Addendum to IFB

IFB NUMBER: IFB 22-028/JW

IFB TITLE: Rehabilitation of Fuel Farm Pavement at the Jack Brooks Regional

ADDENDUM NO.: 2

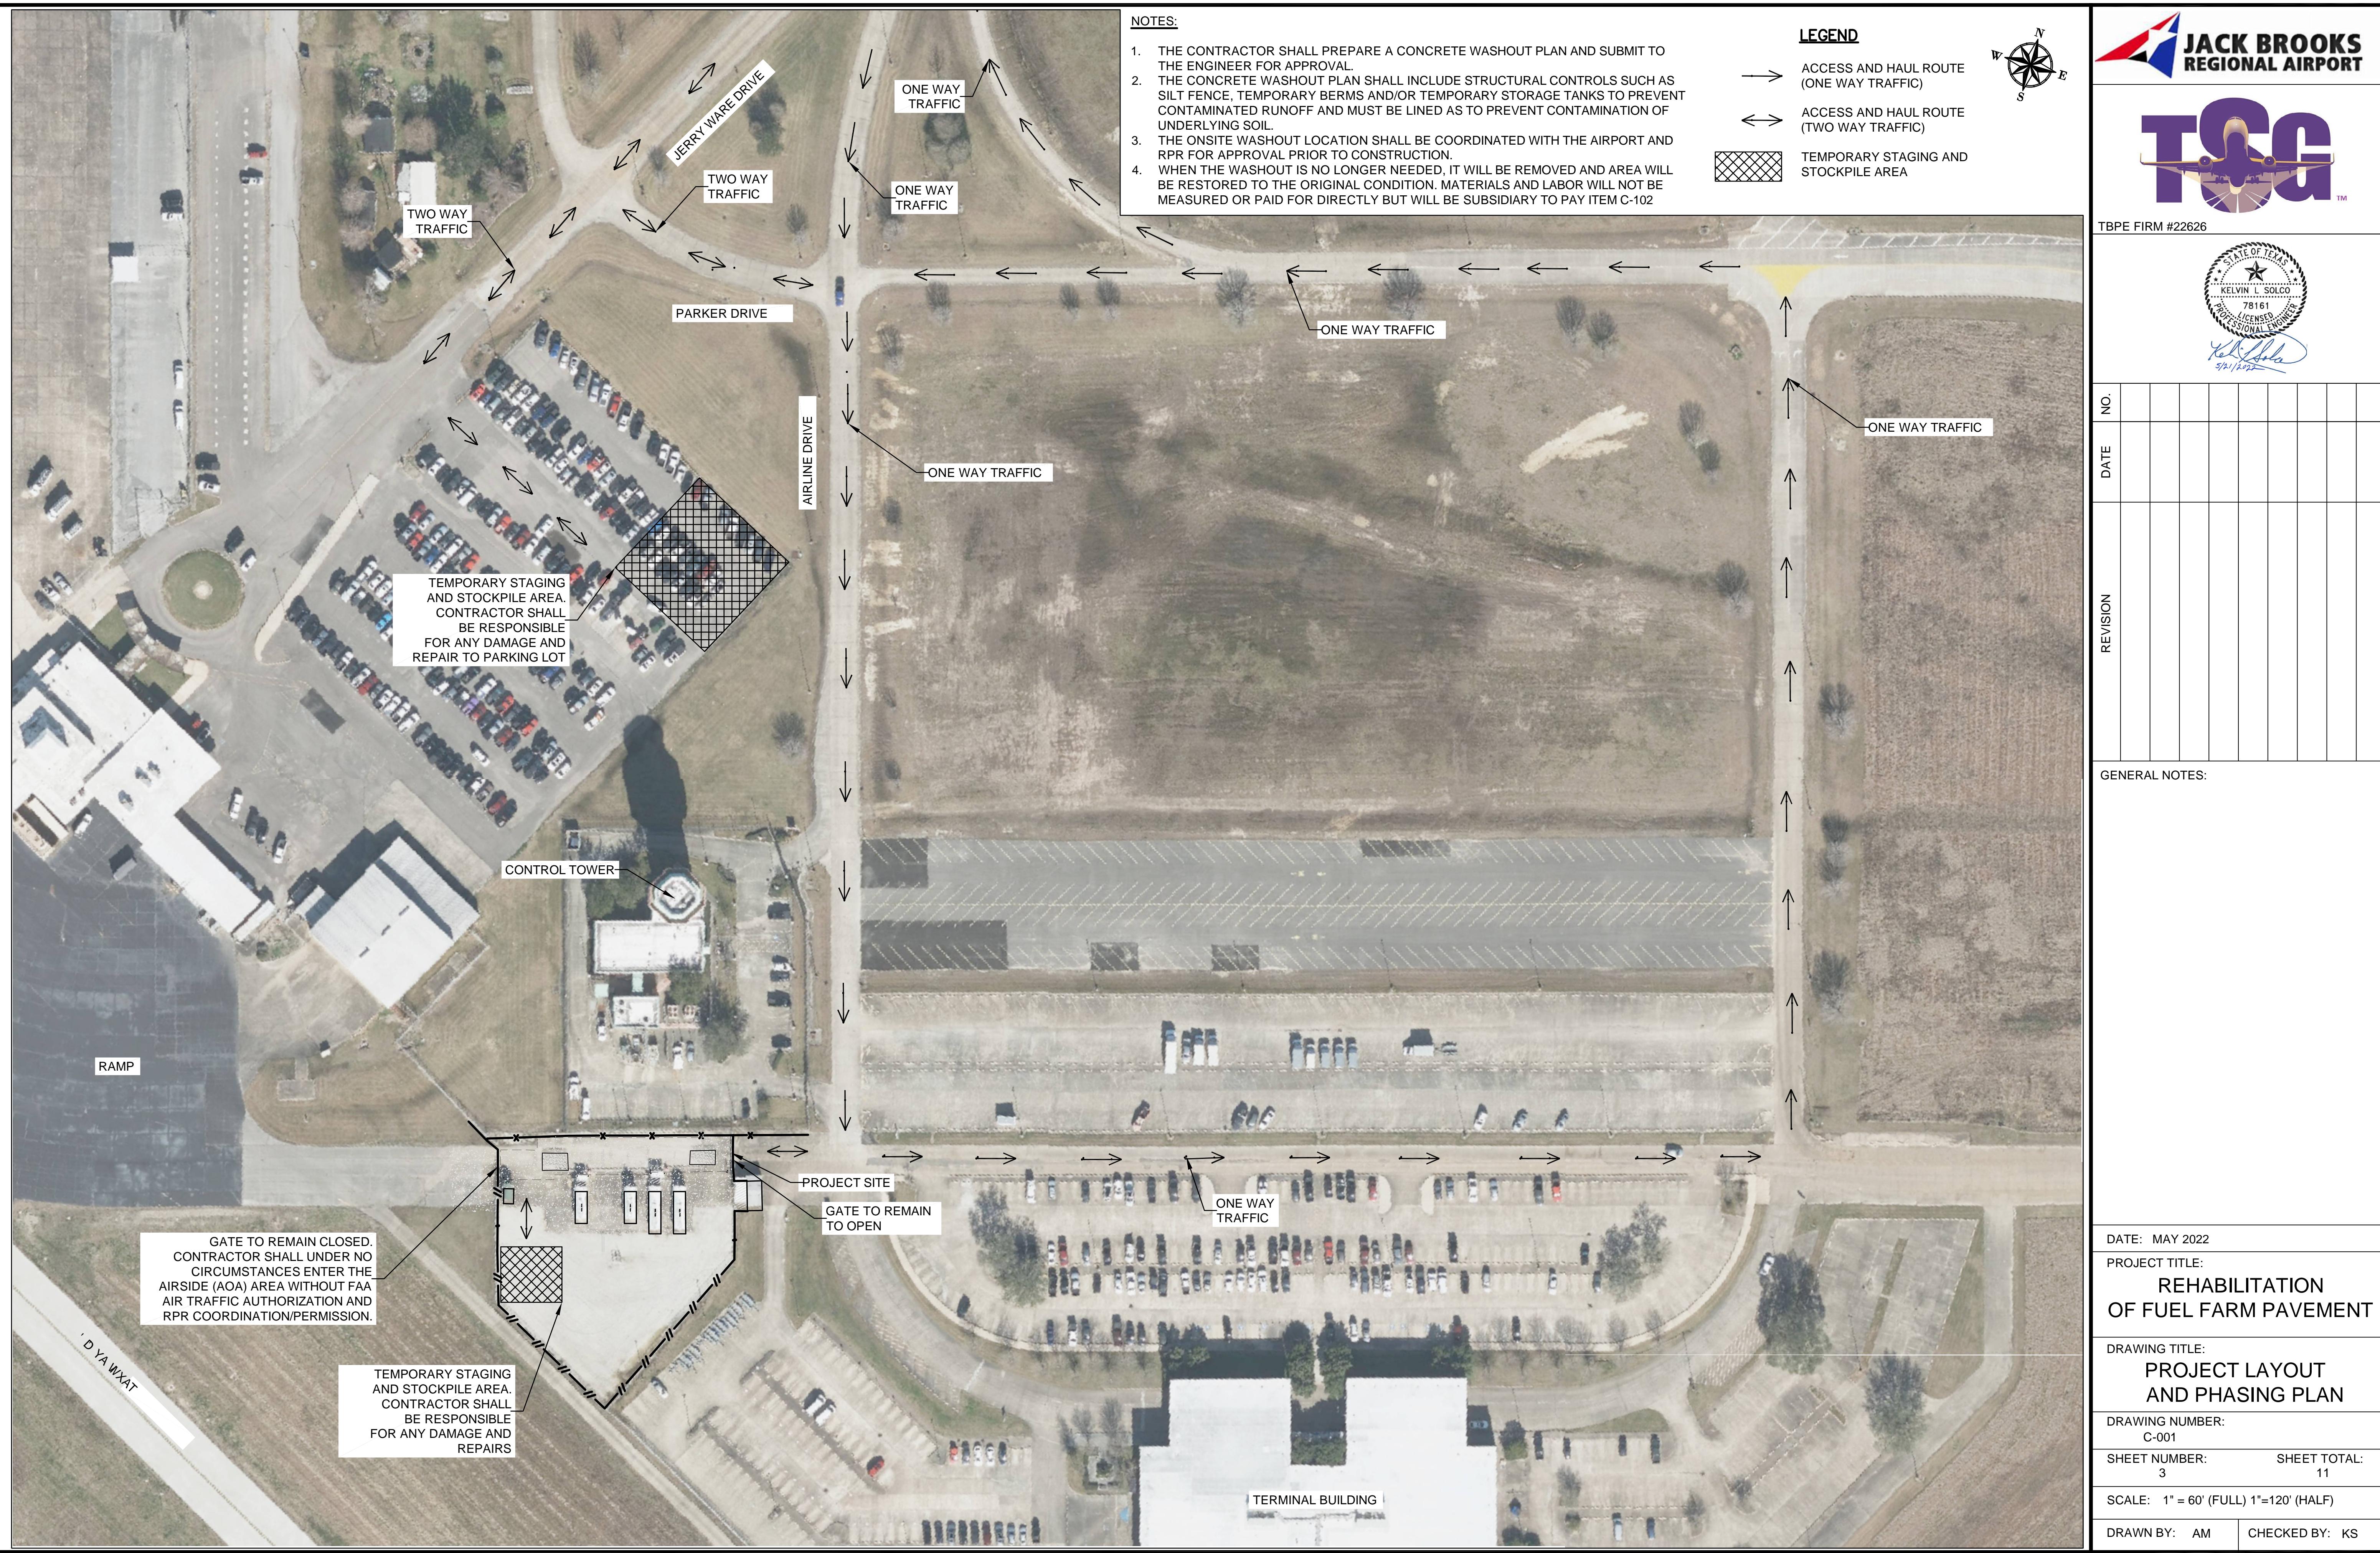
1. Who is responsible for Materials Testing? All quality assurance testing shall be done by the Contractor. Please see the Items below:
 - a. Item 152-5, section 152-2.10 under paragraph 2, last sentence.
 - b. Item 155-4, section 155-6.10 and a. Density Paragraph
 - c. Item 501-7, section 501-3.3 f., 501-3.4 Concrete Mix Submittal, 501-4.8 c. Consolidation, 501-4-11 e. Straightedge testing and surface correction., P-501-24 CONTRACTOR QUALITY CONTROL (CQC)
 - d. Page 8 of 61 of bid documents section 2.12.
2. DRAWING PLAN SHEET 3 – Replace Sheet 3 with New Sheet 3. Arrow for “One-Way” traffic corrected.
3. BID DOCUMENTS – Replace pg. 42 with New Page to include TOTAL BID LINE.
